ADDENDUM NO. 1

Renovation to Exterior/Interior RC Building Warrensburg Readiness Center Warrensburg, Missouri PROJECT NO.: T2306-01

May 17, 2024

A-101 11 OF 53 SHEETS 12/29/2023

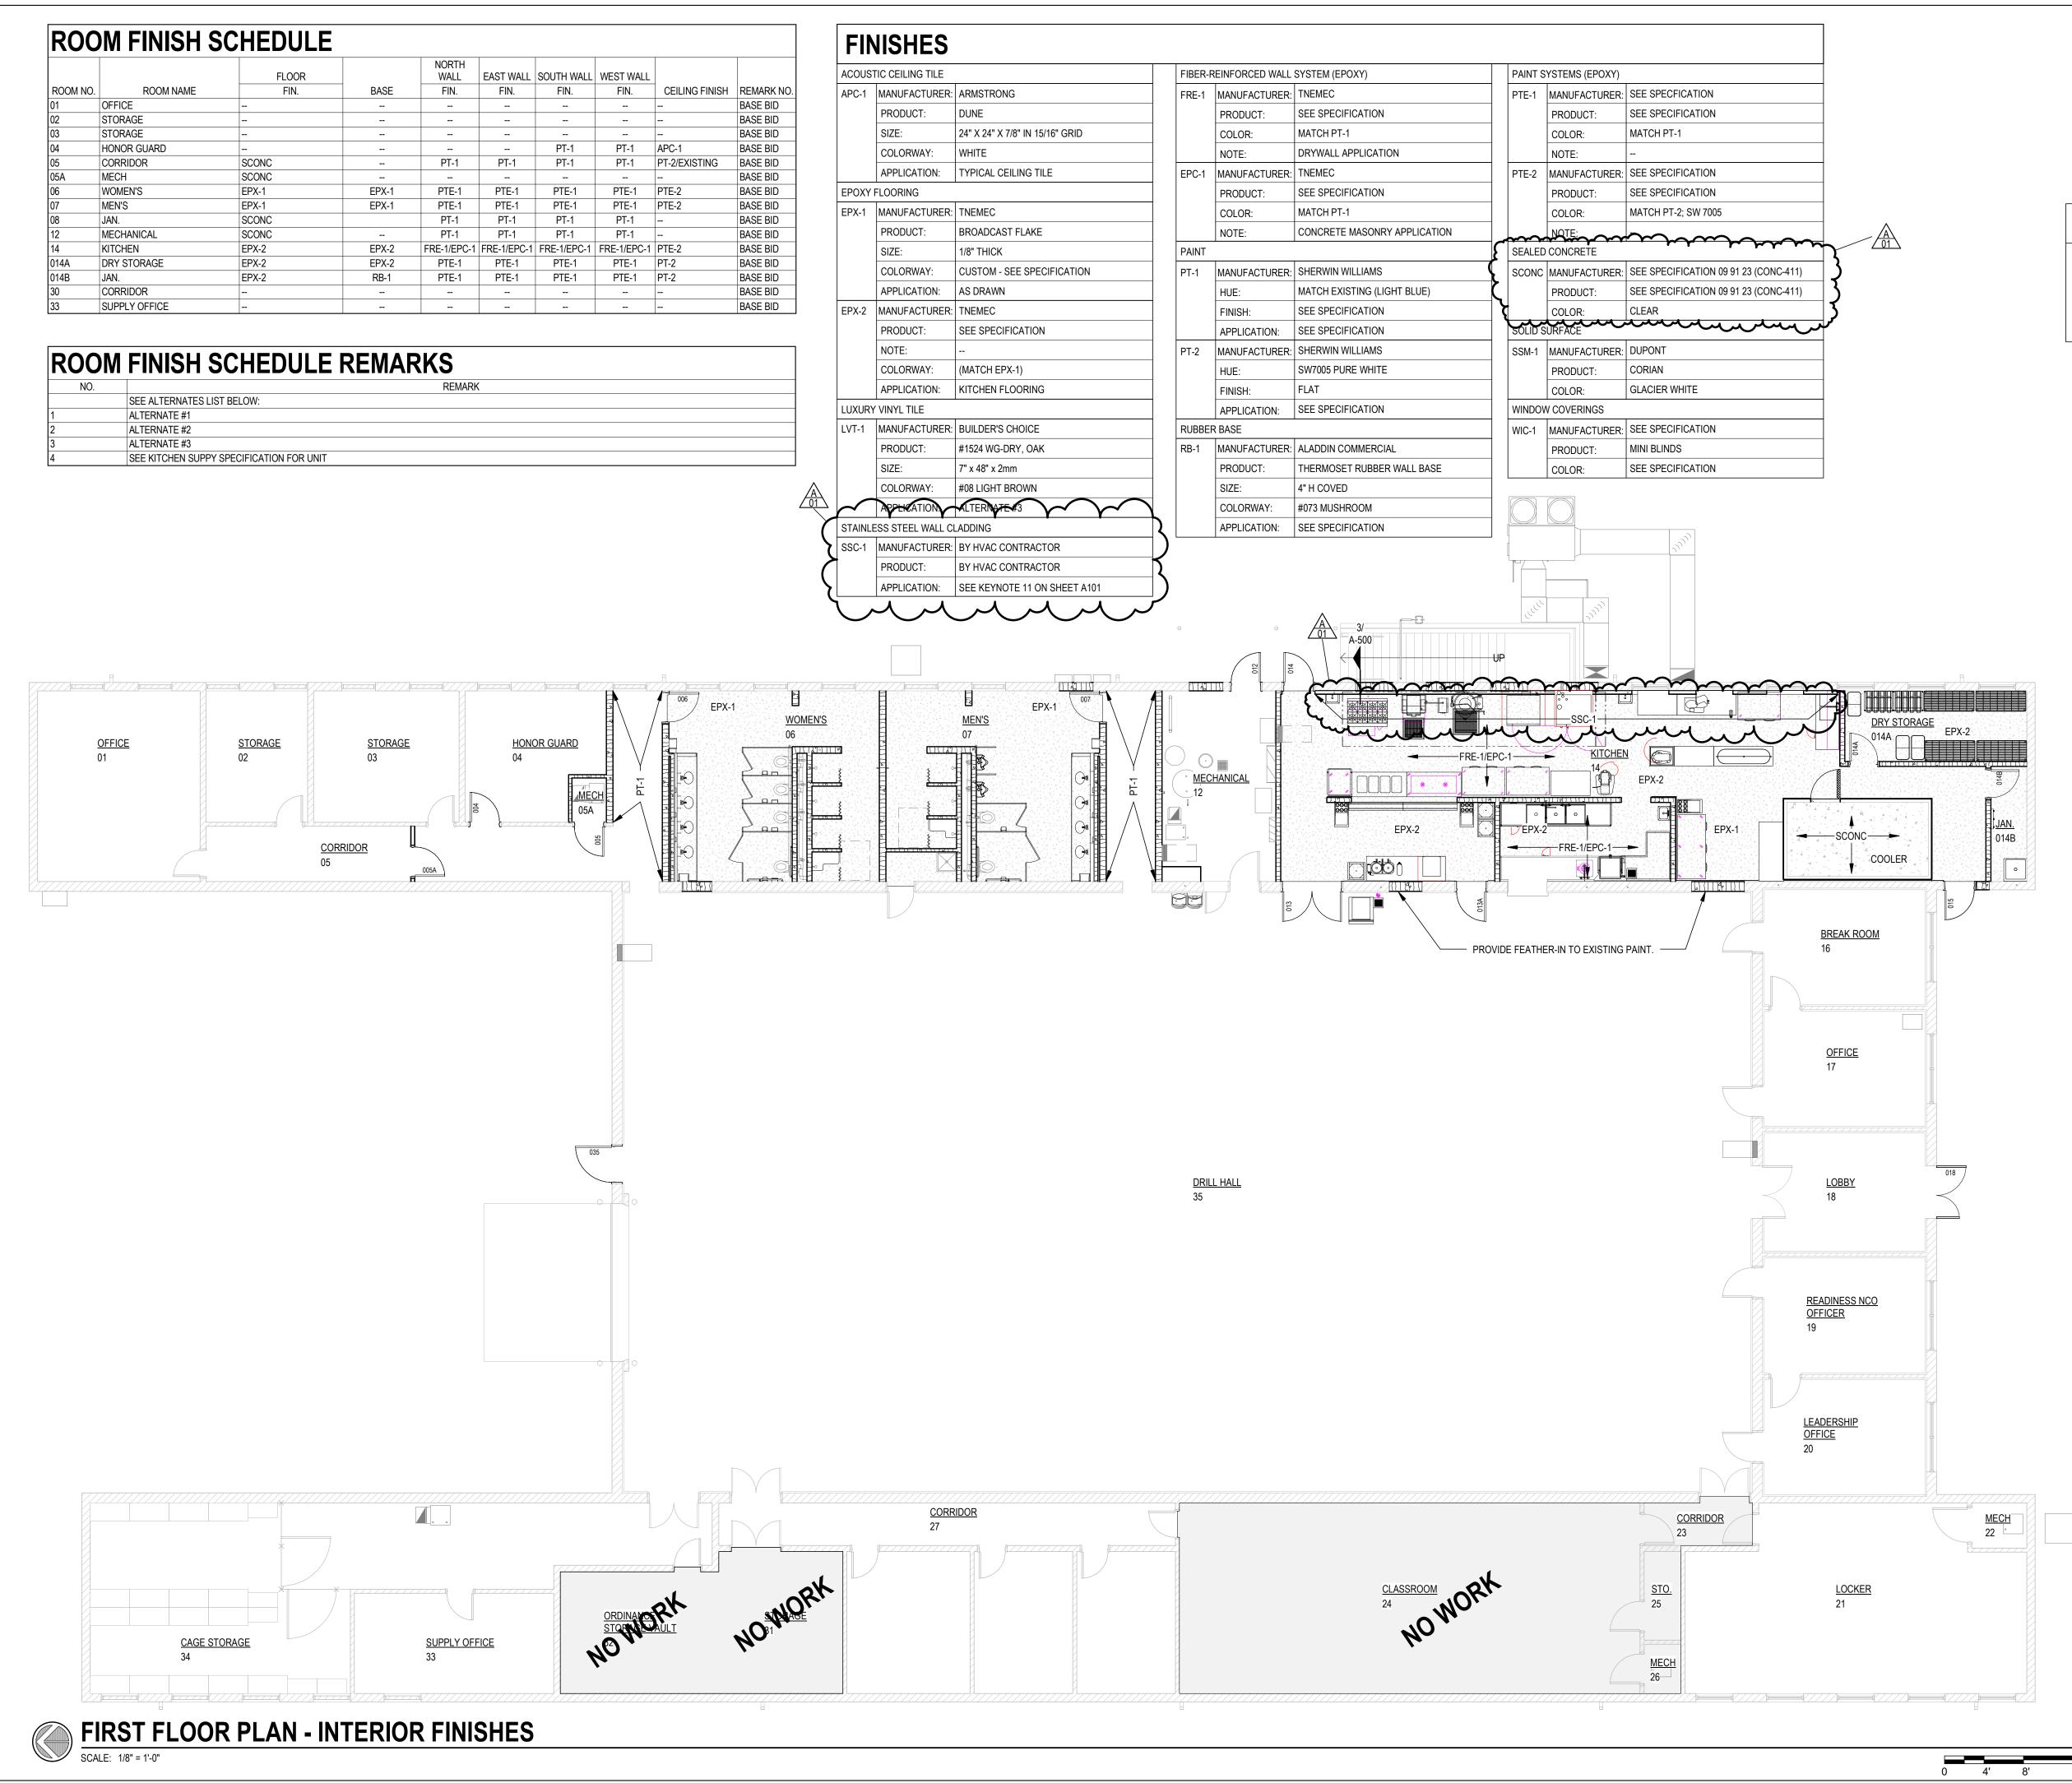
5. Sheet A-101 (attached)

- a. ADD Elevation 5/KITCHEN STAINLESS STEEL WALL CLADDING
- b. ADD Key Note 11: 18 ga. type 304 #4 finish stainless steel sheet, fabricated and installed by the HVAC contractor. Furnish cut-outs at all utility penetrations through the wall cladding. Install stainless steel divider bars at vertical joints, screwing the divider bar to the substrate. Adhere stainless wall cladding to the substrate with PL400 heavy duty construction adhesive. Use a plastic v-groove trowel to provide full coverage to the sheet, place in position on the wall, pull the sheet away to allow adhesive to vent until tacky, then press and roll the sheet to the substrate. Cladding above the hood may be galvanized.

- c. ADD Furring wall (type A3) to full length of East wall in kitchen.
- d. ADD Note to 4/Basement Floor Plan Base Bid: Provide new sleeve/ penetration through wall at basement locations. See Sheet P-101 for routing details.

F-100 18 OF 53 SHEETS 12/29/2023

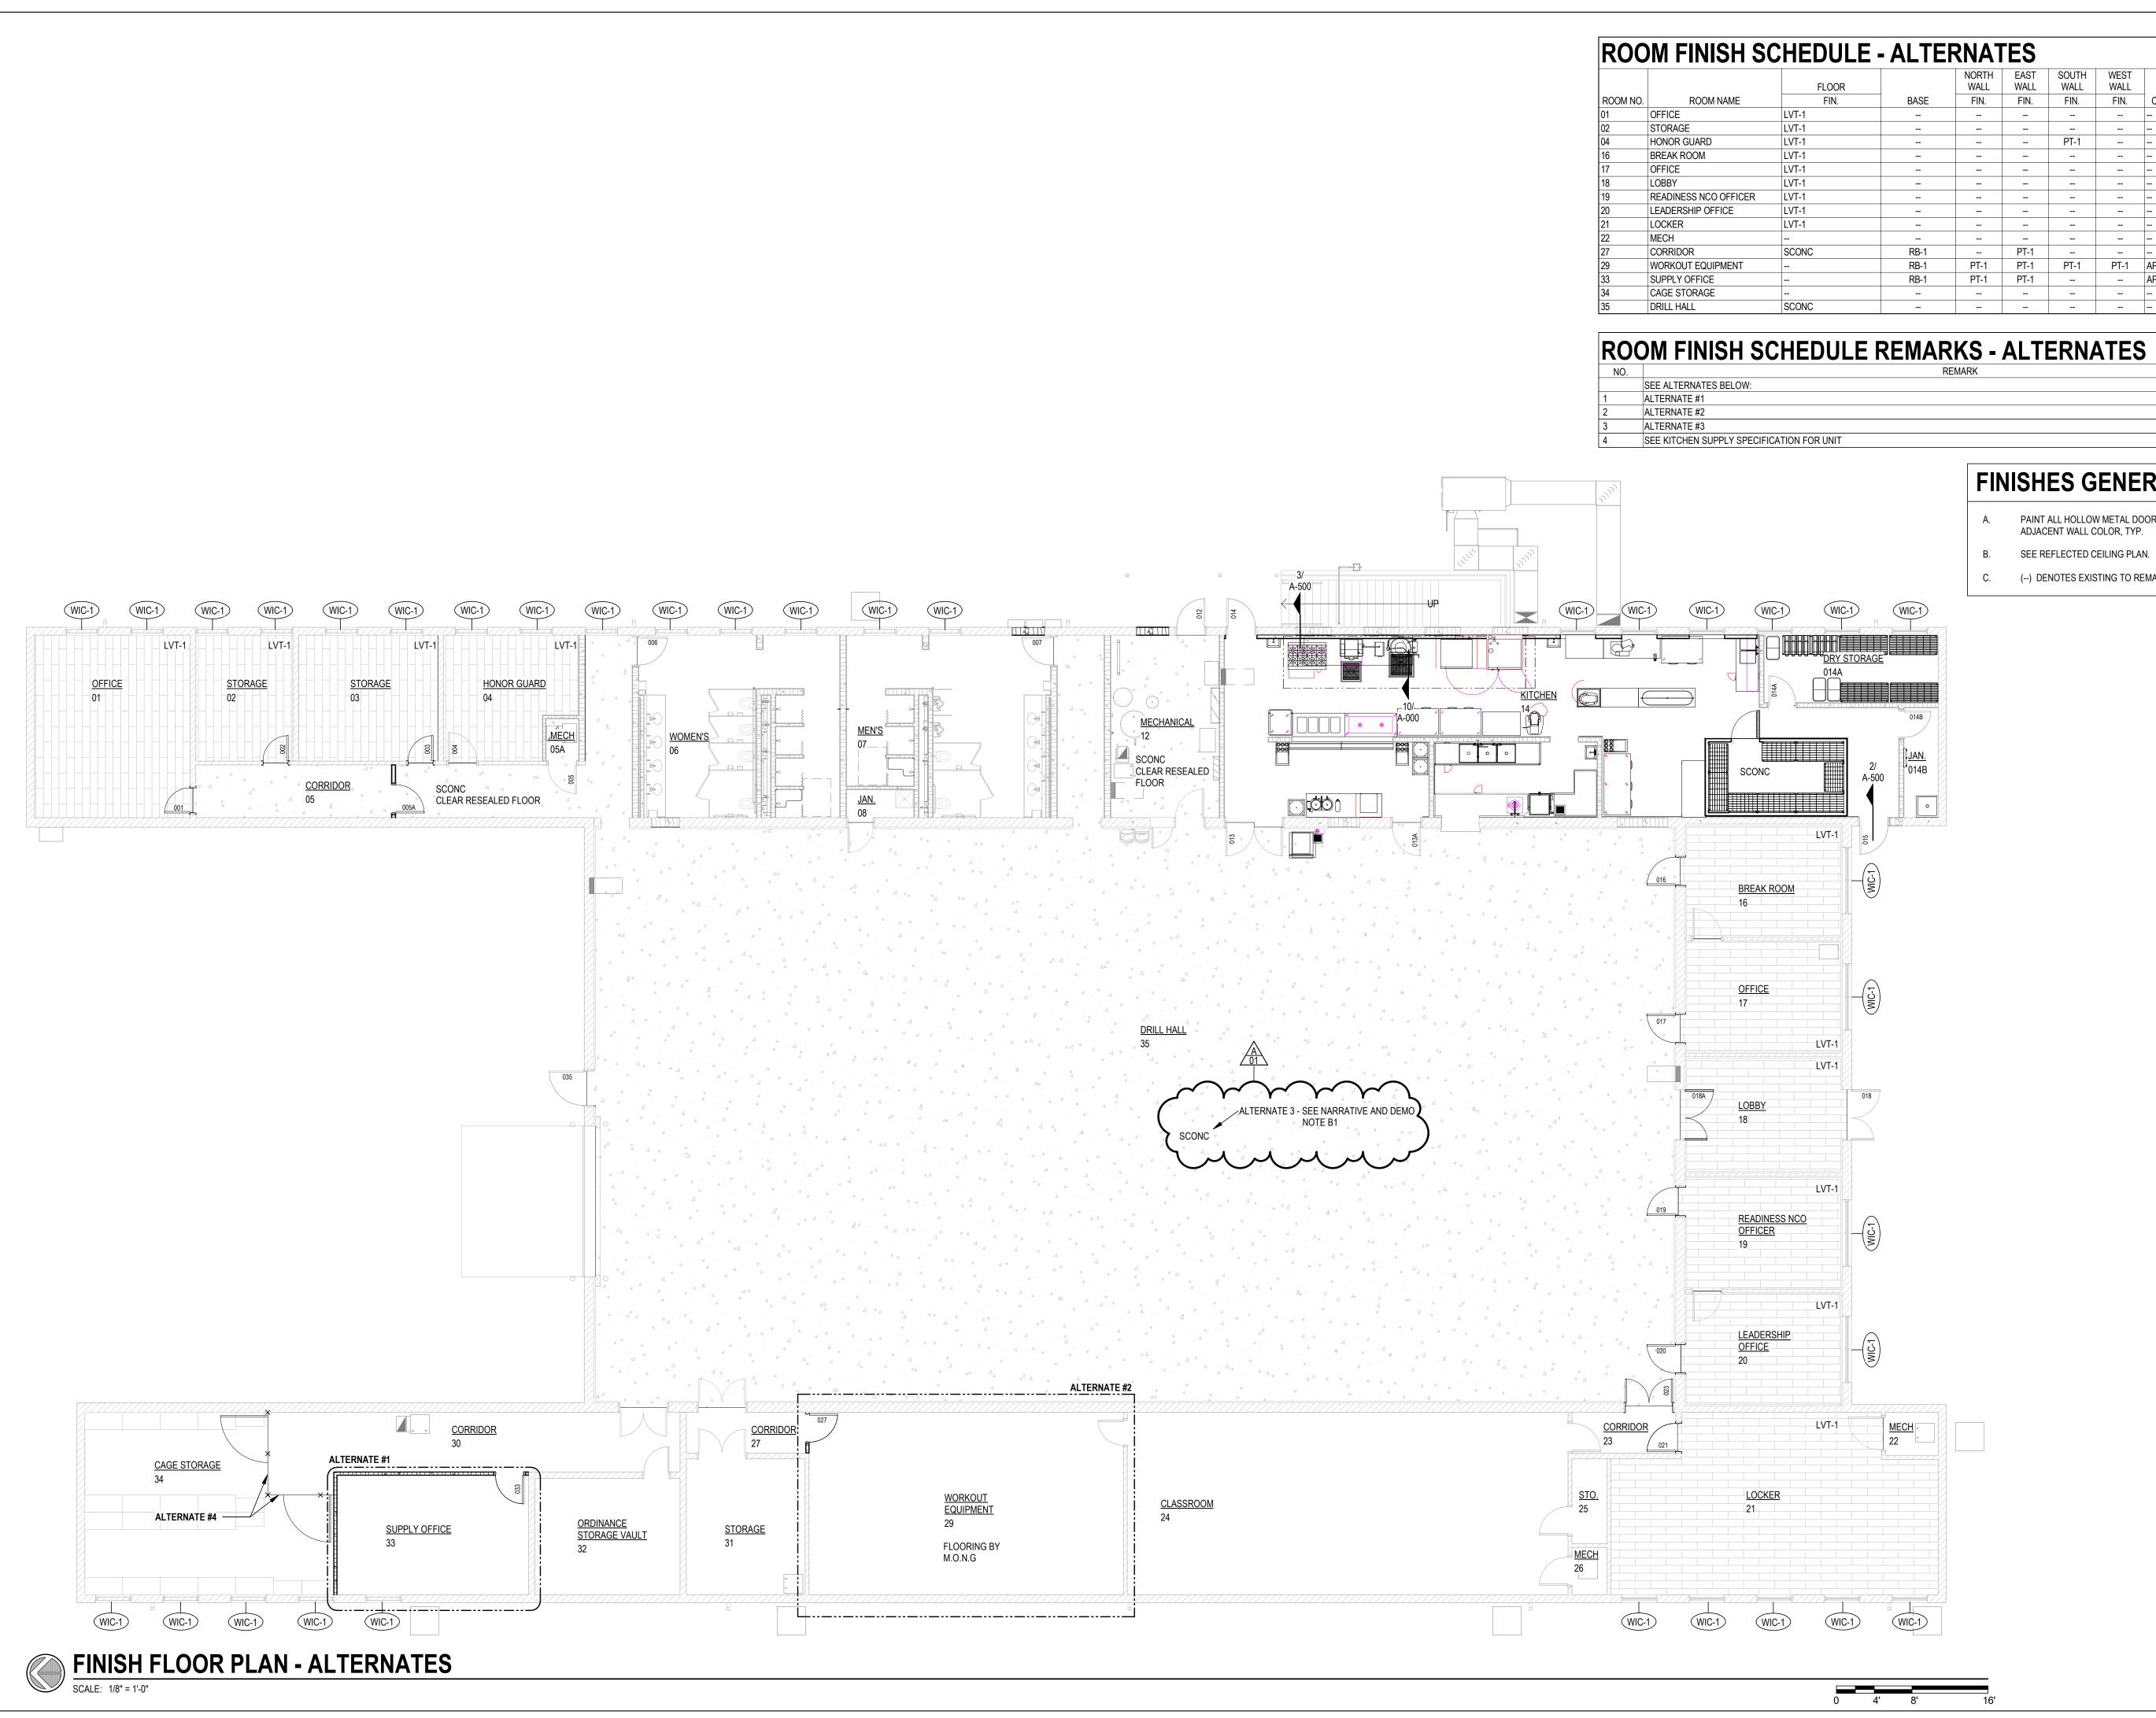
- 6. <u>Sheet F-100 (attached)</u>
 - a. ADD SSC-1 finish tag to East wall in Kitchen.

- b. ADD SSC-1 to Finishes legend.
- c. ADD SCONC to Finishes legend.

F-101 19 OF 53 SHEETS 12/29/2023

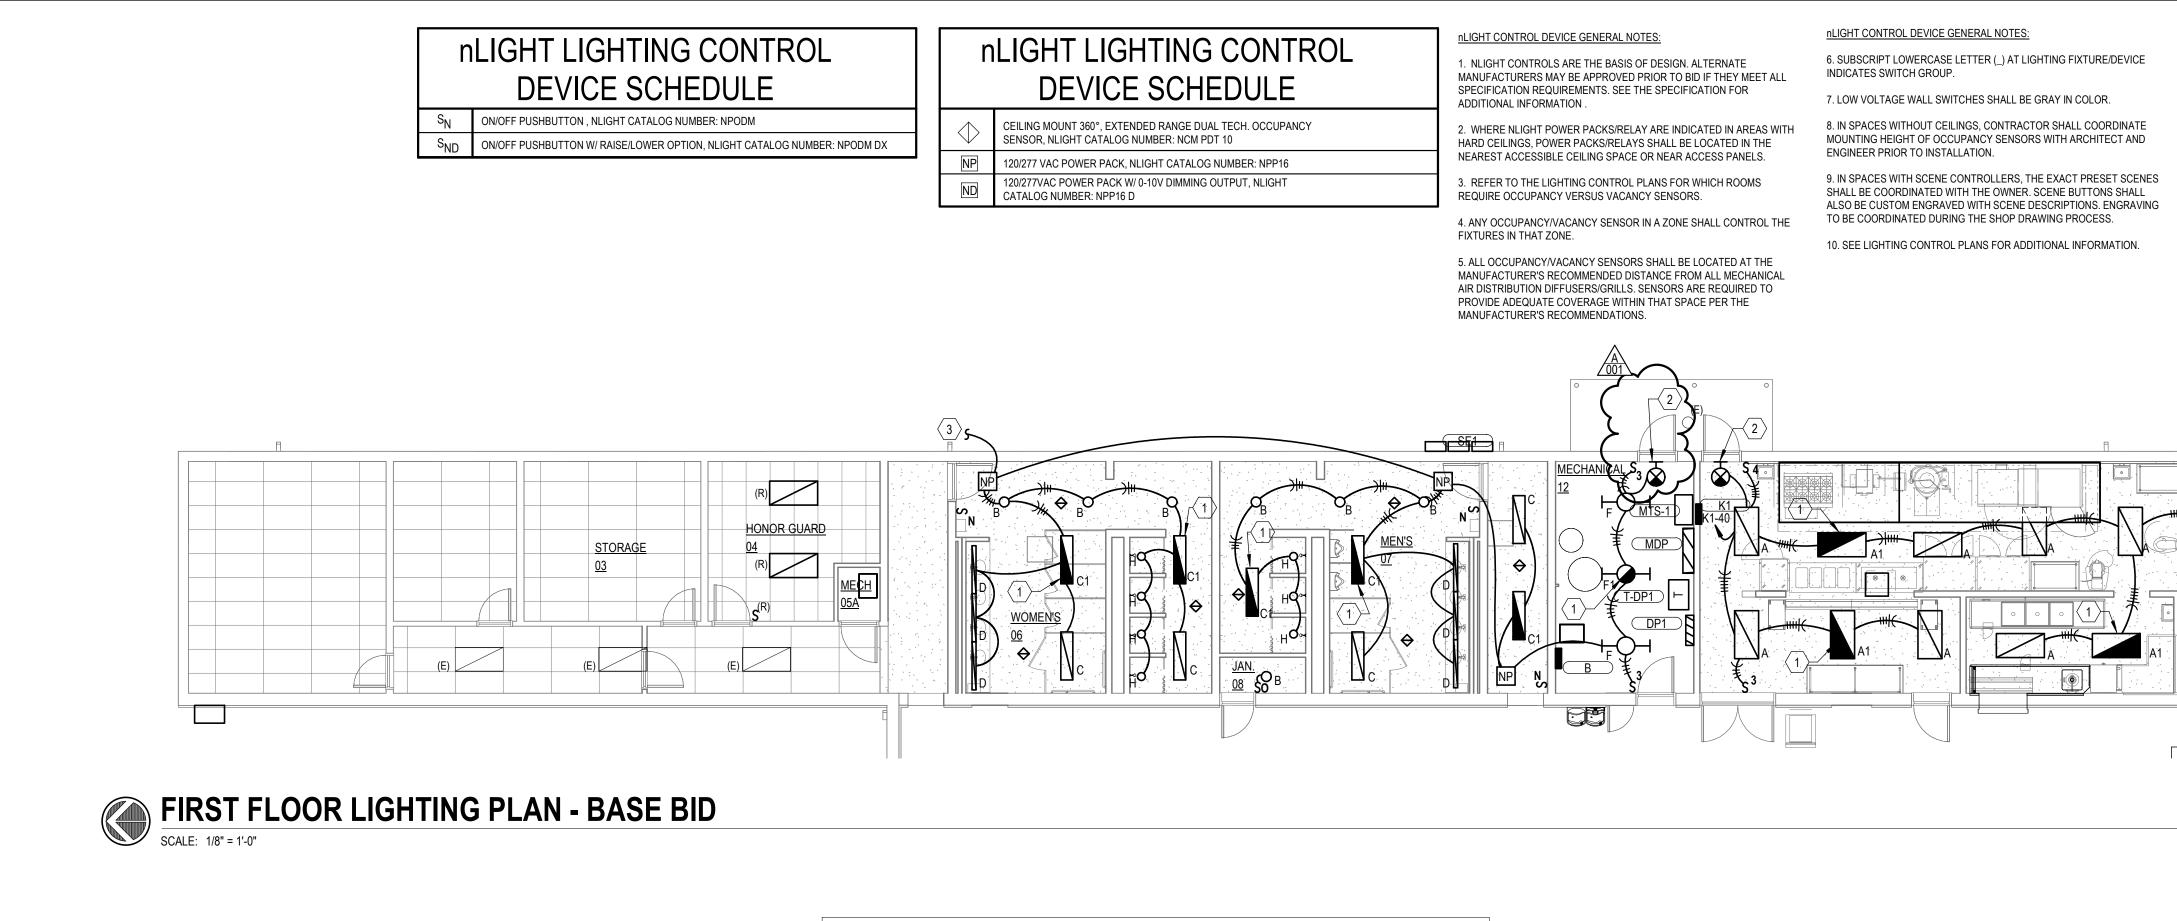
7. Sheet F-101 (attached)

a. ADD Note to sealed concrete floor: See Alternate 3 narrative and Demolition Key Note B1.
